STAFF REPORT
SAUSALITO PLANNING COMMISSION/ HISTORIC LANDMARKS BOARD

Project:	**Chase Bank - 675 Bridgeway** **Sign Permit** **DR/SP 13-213**
Meeting Date:	November 13, 2013
Staff:	Steve Padovan, Contract Planner

Approval of a **Design Review Permit** and **Sign Permit** to allow for a 5.7 square foot hanging sign in the entry alcove of a Chase Bank branch to be located in the Downtown Historic Overlay Zoning District at 675 Bridgeway.

ELEVATION SCALE: 1 ½' = 1'-0"

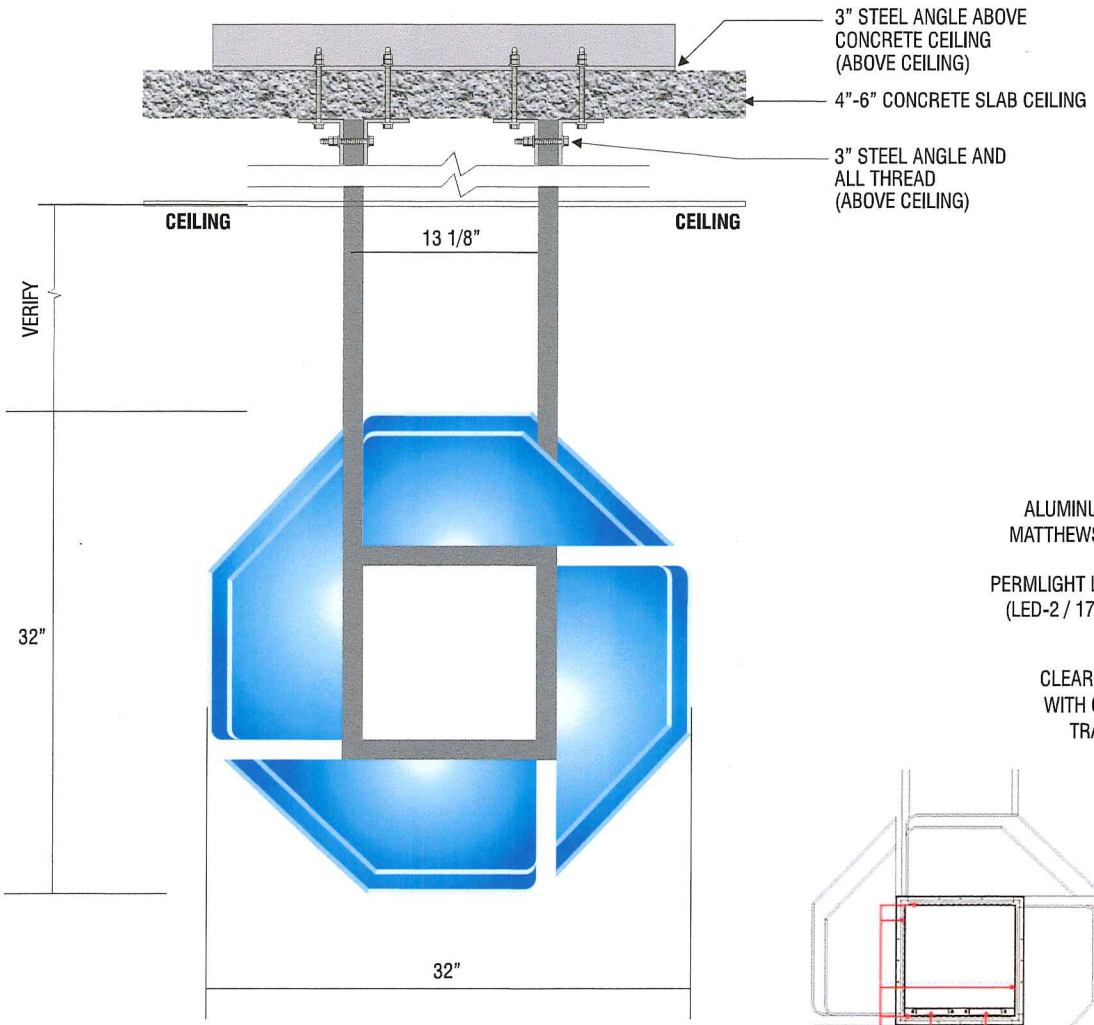
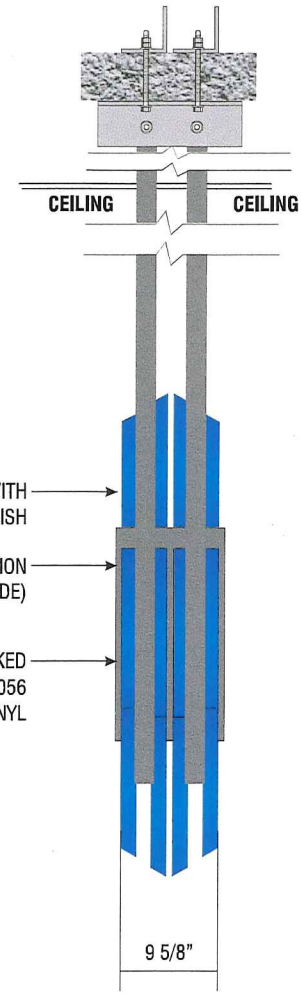
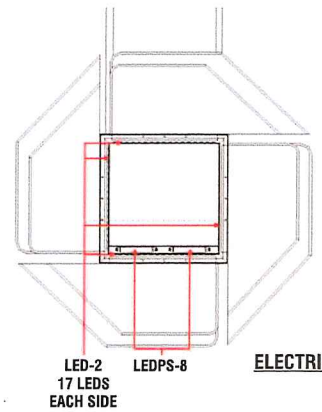
- Installation of a 5.7 square foot hanging internally illuminated Chase logo sign. The sign will hang inside the entryway between the two sets of glass doors and be halo lit. The sign materials will consist of aluminum housing, a clear acrylic face backed with "Oracal Translucent Vinyl", and LED lights to create a halo effect. (see page 8 of the project plans)

area for the property to the maximum permitted 12.5 square feet. However, the new hanging sign exceeds the maximum permitted area of four (4) square feet.

The illuminated hanging sign is located in the ATM vestibule between the two sets of glass doors and utilizes a halo type effect to minimize glare and produce a muted lighting effect. The ATM vestibule itself will also be illuminated for security reasons so the subdued halo effect should not produce any significant additional light and glare.

10. The proposed hanging sign shall comply with the signage plans titled "JP Morgan Chase Bank" date stamped August 14, 2013. The maximum permitted sign area for the hanging sign shall be 5.7 square feet.
